REMARKS

Appl. No. 10/533,749
Amdt. Dated 9/5/2007
Reply to Office Action of 3/8/2007

Fig. 5

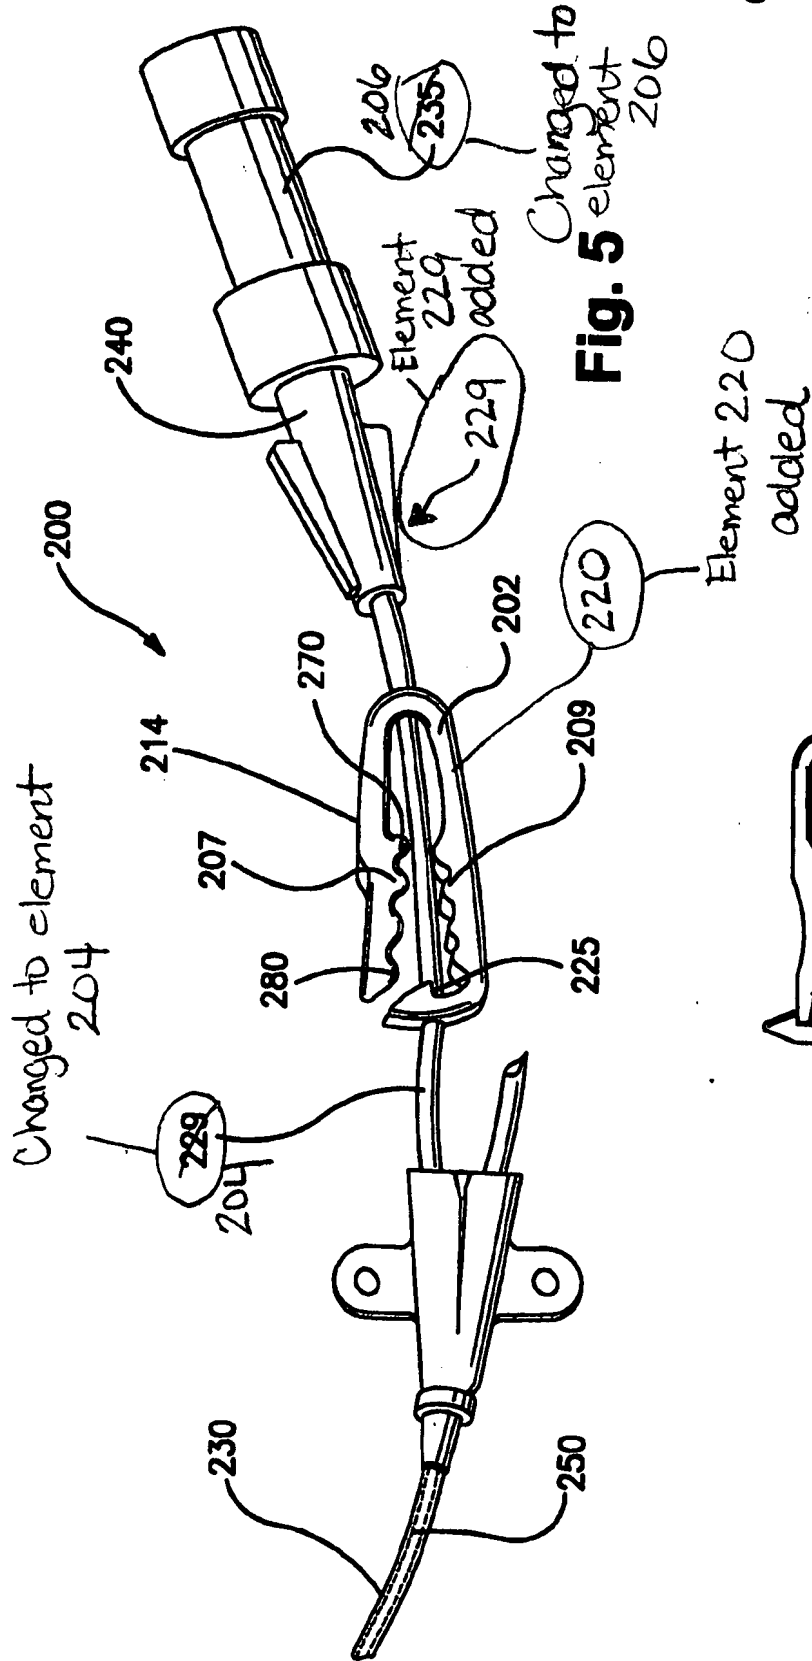
The attached sheets of drawings include changes to Fig. 5 and Fig. 7. The first sheet, which includes Figures 5-6, replaces the original sheet including Figures 5-6. In Figure 5, element 229 has been changed to 204, element 270 has been changed to 208, element 235 has been changed to 206, and previously omitted element 220 has been added.
